DESCRIPTION Expansion Dam Detail
PROJECT Sandy River Bridge Proj. No. BH-025-2(46)
LOCATION New Sharon, Me.
DESIGNER Me. D.O.T.
CUSTOMER Callahan Bros., Inc.
JOB NO. 89-670-4
DWG. NO. 22
REV. ②

STATE OF MAINE
DEPARTMENT OF TRANSPORTATION
☒ Approved ☐ Returned for Corrections
AUG 16 1989
☐ Approved as noted ☐ Rejected
K. Jacobs
WELDING ENGR.

DESCRIPTION SPLICE PLTS FOR LINK RETROFIT
PROJECT SANDY RIVER BRIDGE PROJ. No. BH-025-4(26)
LOCATION NEW SHARON, ME
DESIGNER ME DOT
CUSTOMER CALLAHAN BROS.
JOB NO. 89-670-2   DWG. NO. 1   REV. (A)

DESCRIPTION EXPANSION DAM DETAIL
PROJECT SANDY RIVER BRIDGE PROJ. NO. BH-025-2(46)
LOCATION NEW SHARON, ME.
DESIGNER ME. D.O.T.
CUSTOMER CALLAHAN BROS., INC.
JOB NO. 89-670-4
DWG. NO. 21
REV. ⚠1

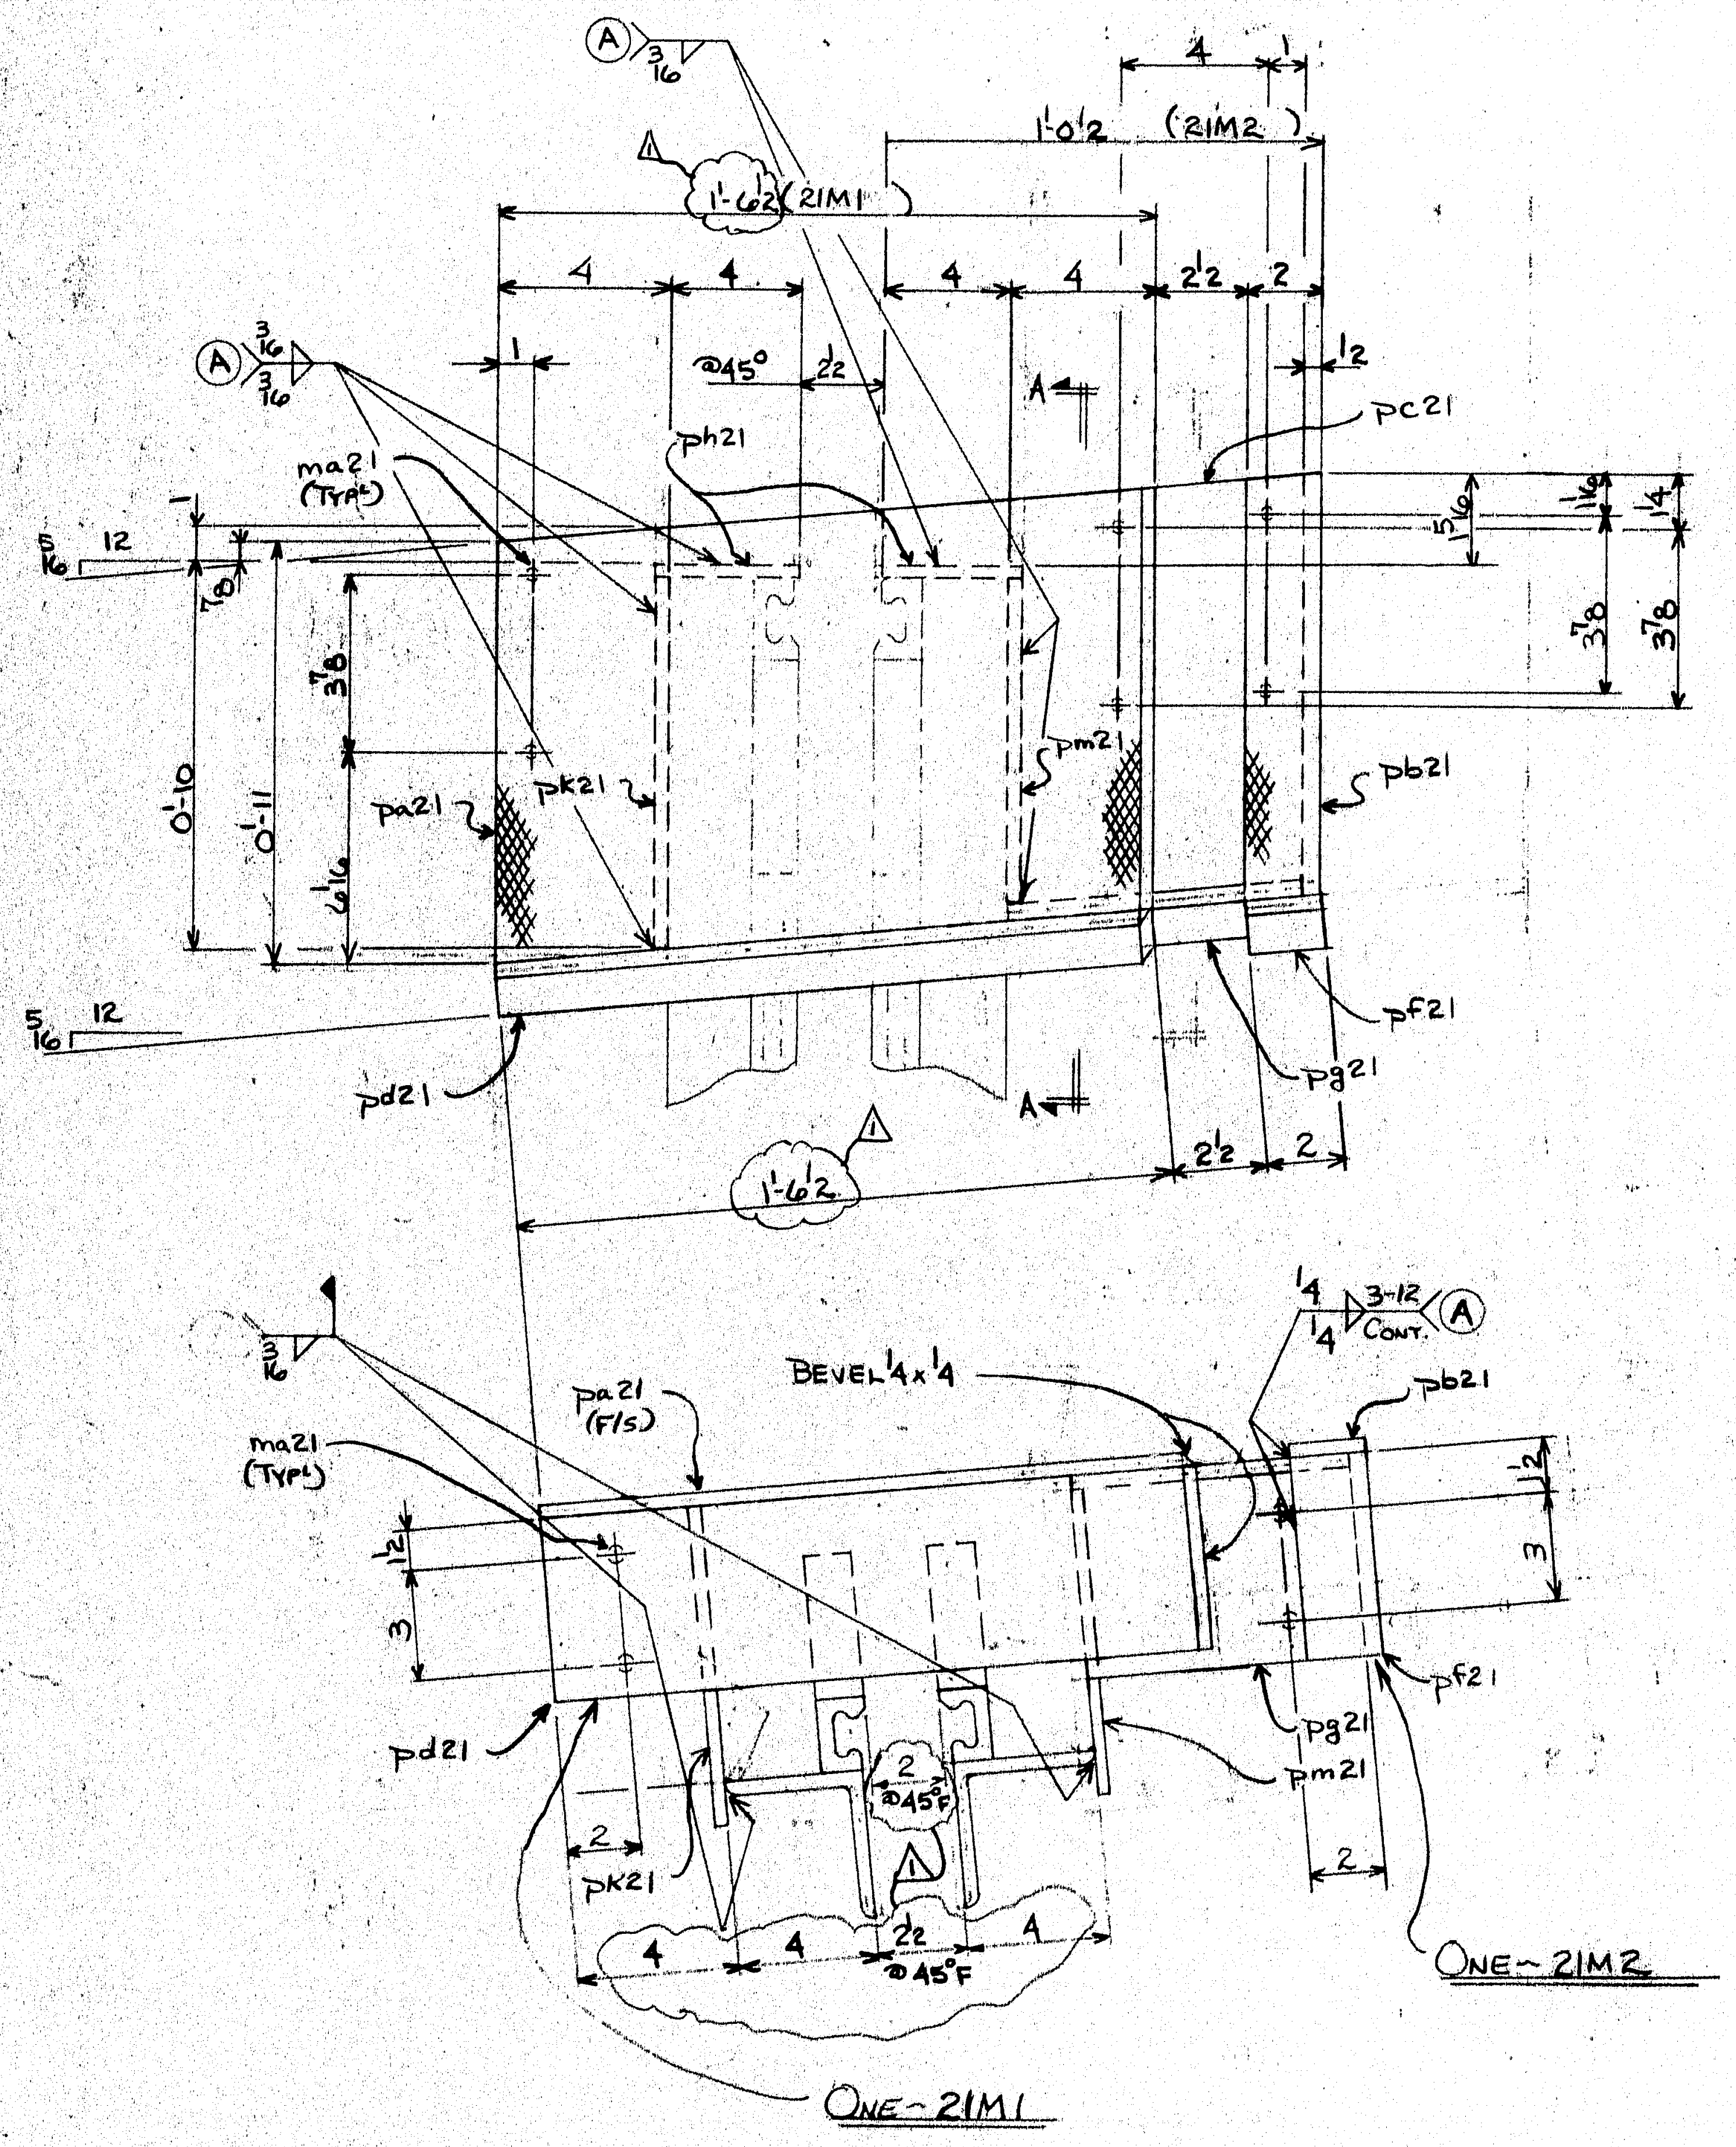
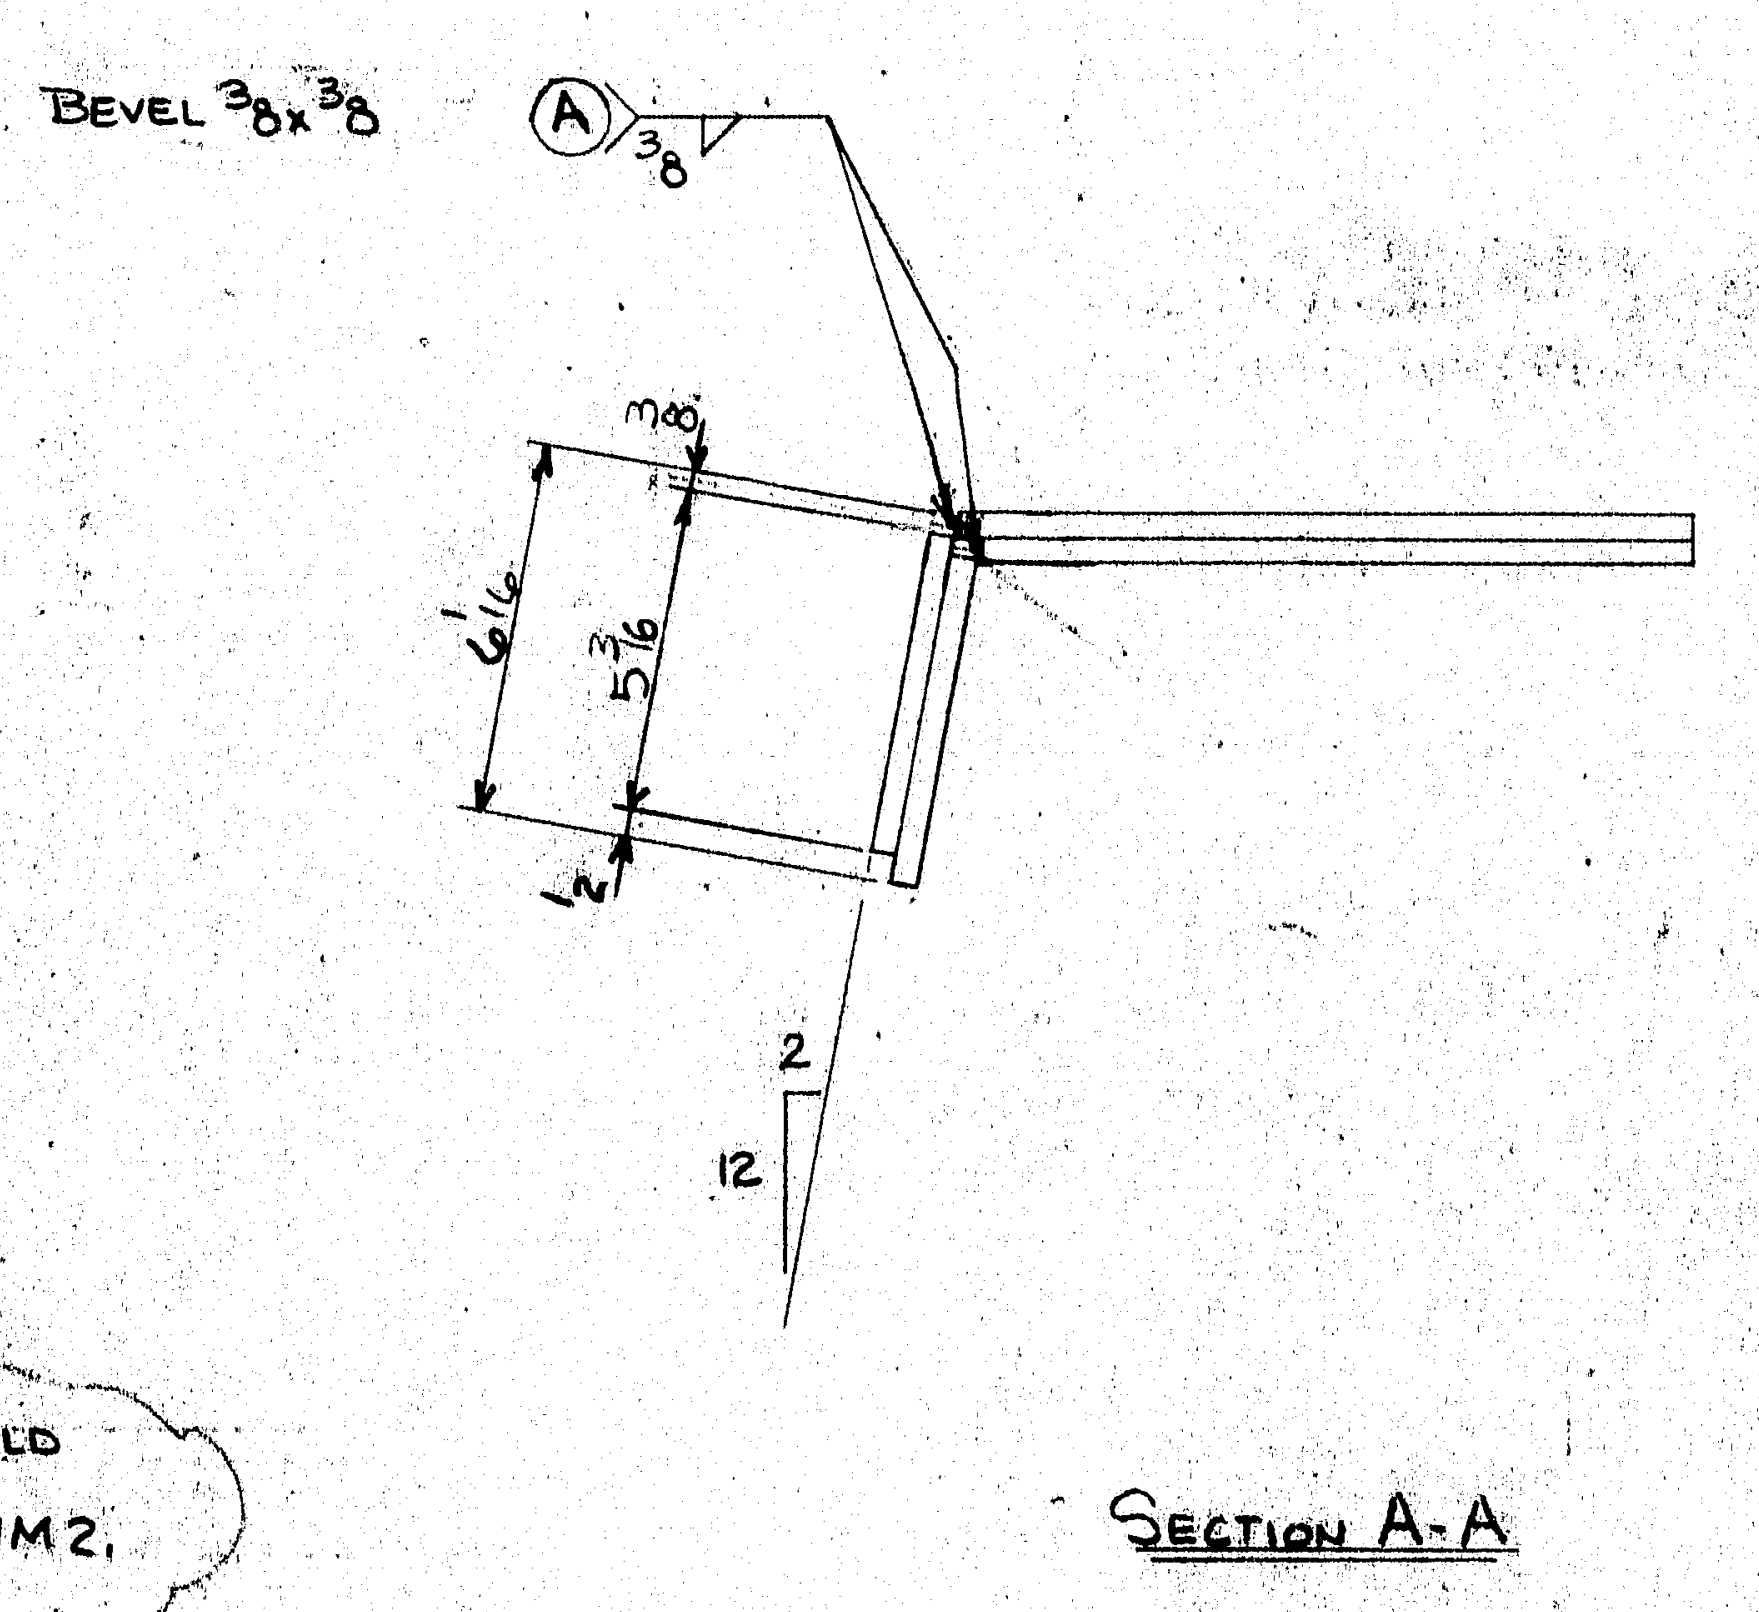
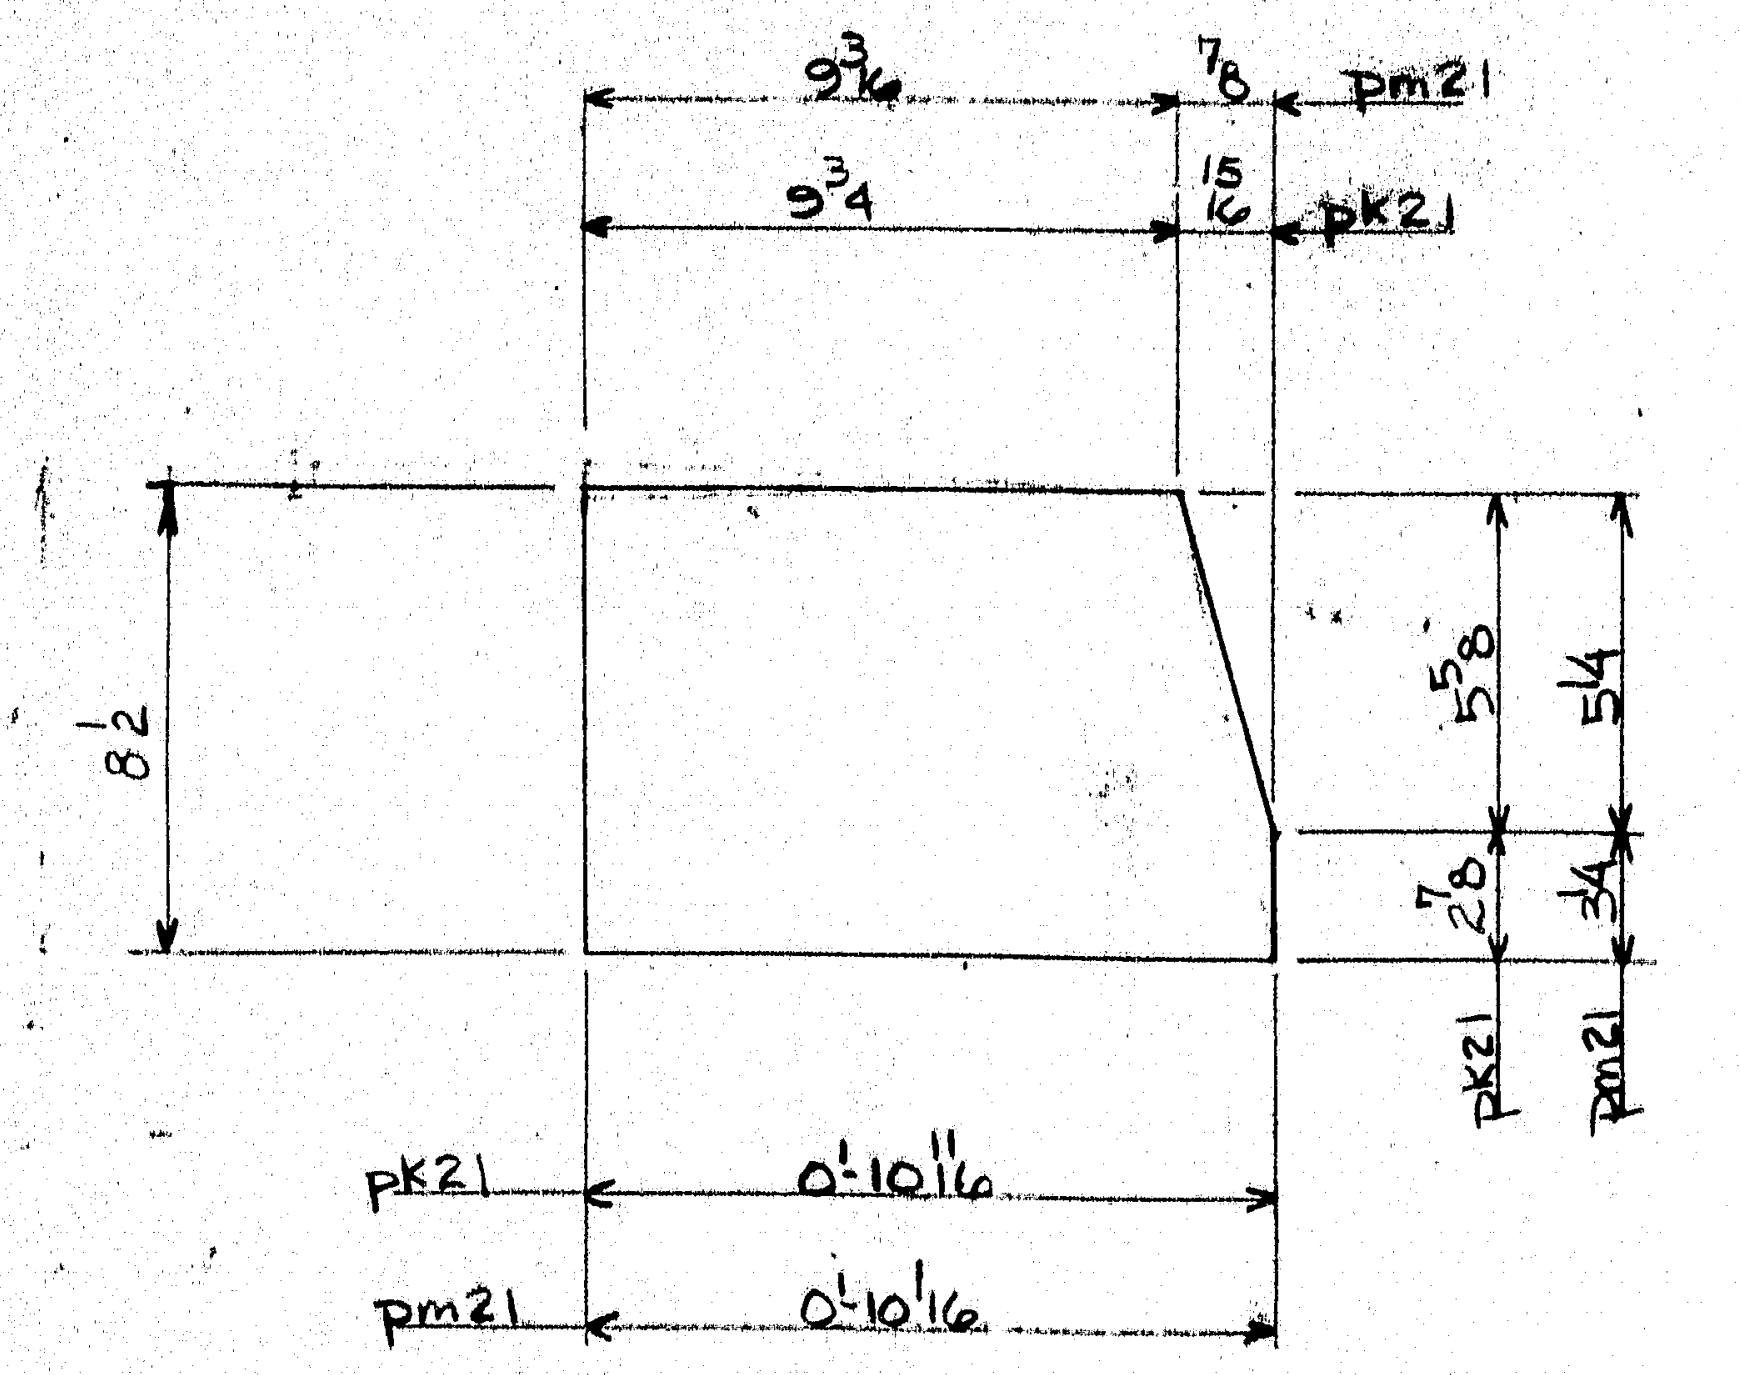
⚠A REVISED PER APPROVAL ⚠1 CHANGED 1'-6 TO 1'-6 1/2 & ADDED DIMENSIONS.
